ATTACHMENT 3

**PROPOSED TECHNICAL
SPECIFICATIONS**

Technical Specification 5.0

"DESIGN FEATURES"

FIGURE 5.1.B-1

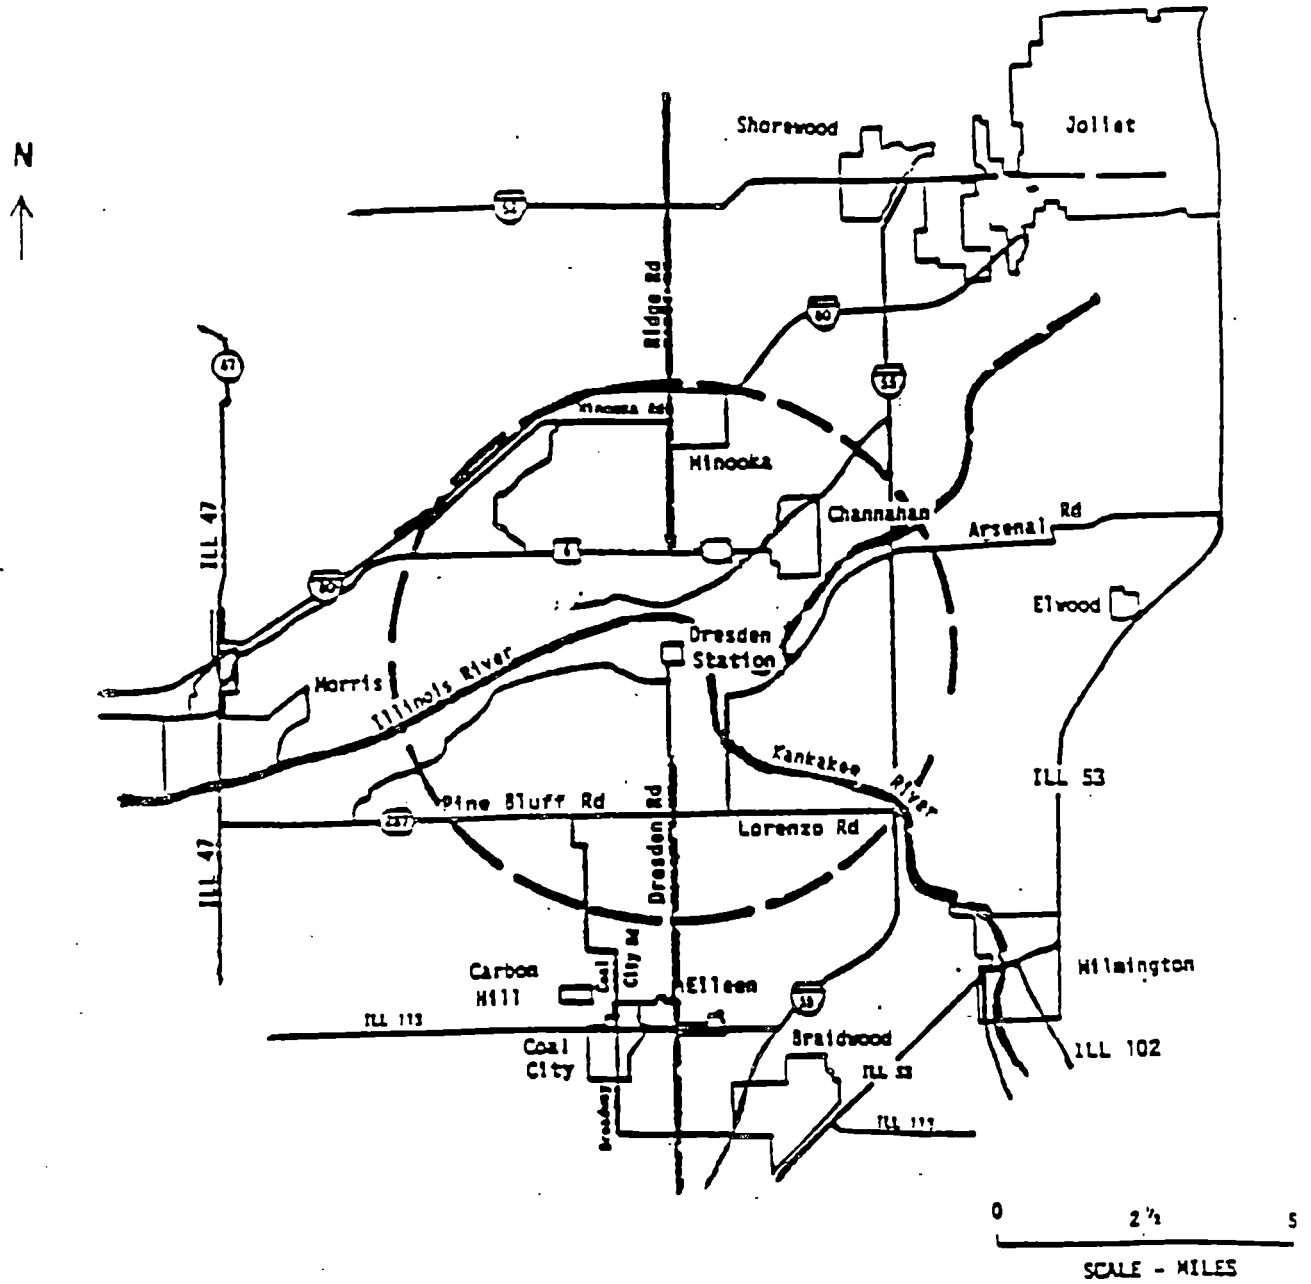
5.1.B The low population zone shall be as shown in Figure 5.1.B-1.

FIGURE 5.1.B-1

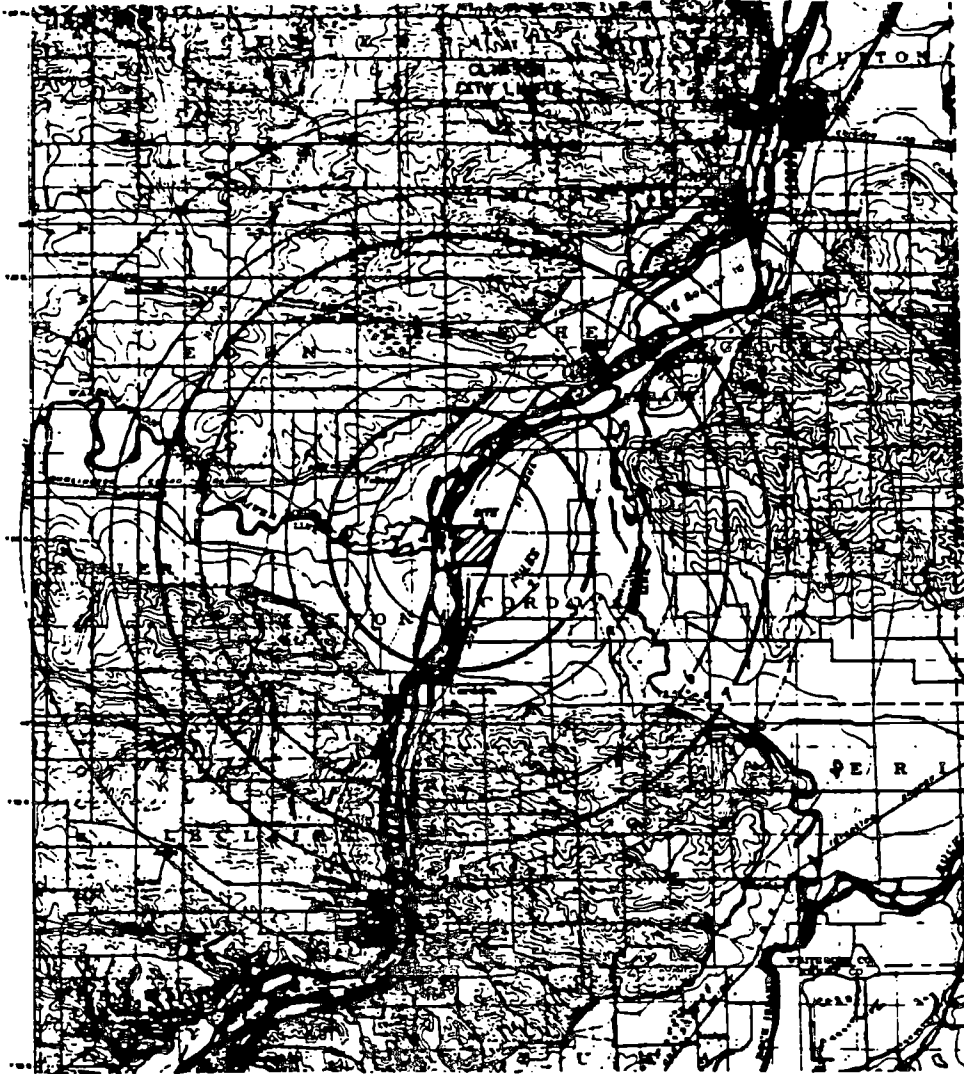
5.1.B The low population zone shall be as shown in Figure 5.1.B-1.
